IDWR rulemaking "dam safety" problems

Key safety design requirements for dams and tailings dams

Flood Release Capability Requirements, generally reduced

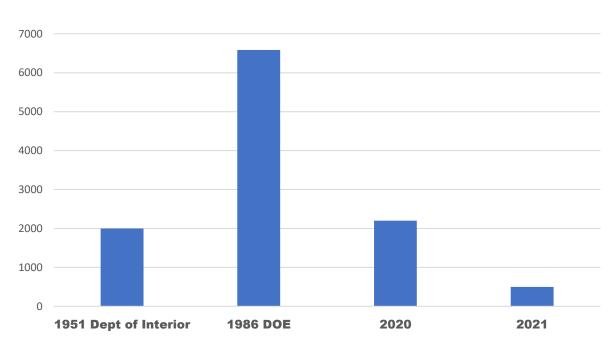
- Reduced Inflow Design Flood (IDF) requirement
- IDWR's focus on reducing requirements, and not prevention of dam/tailings dam failure
- IDWR does not appear to consider the increases in flooding hazard posed by climate change that are widely recognized
- History of IDWR failure to adequately assess IDF capacity for existing dams
